SERVICE BULLETIN NO: 070710-R1

**Models:** TX-SR605/DTR5.8

Subject: Static (pop) noise in DSP mode

Fig 2.

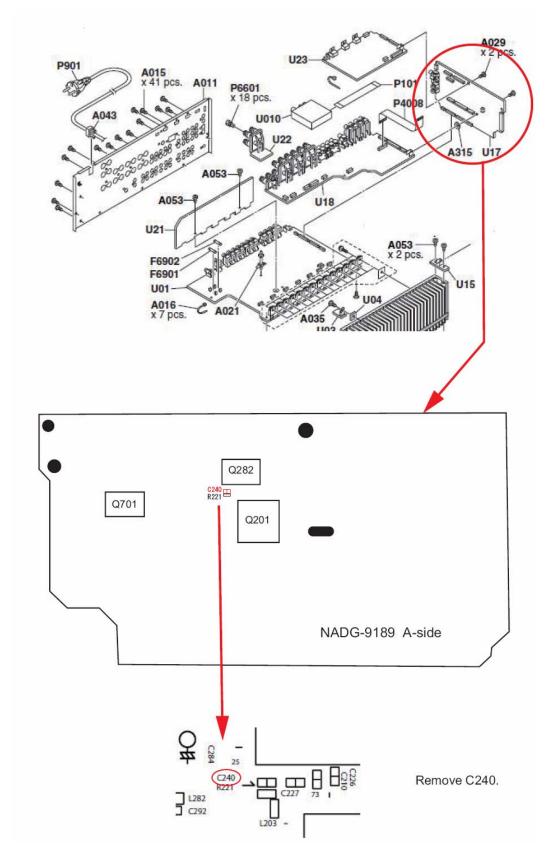
**Symptom**: During playback in any listening modes except Analog Direct, Multi-ch, and 2ch Pure Audio, Static (Pop) noise randomly comes out from all channel speakers, when the internal temperature is high. This noise stops when the unit is cooled (internal temperature is low)

**Cause**: When the internal temperature becomes high: depending on the variation of IC quality, SDRAM clock cannot catch up with the data reading speed.

When the above problem is reported, remove C240 from DSP Board NADG-9189. Place the unit as shown in Fig 1. below and then remove C240 as shown in Fig 2.

# **DSP Board: Remove C240**
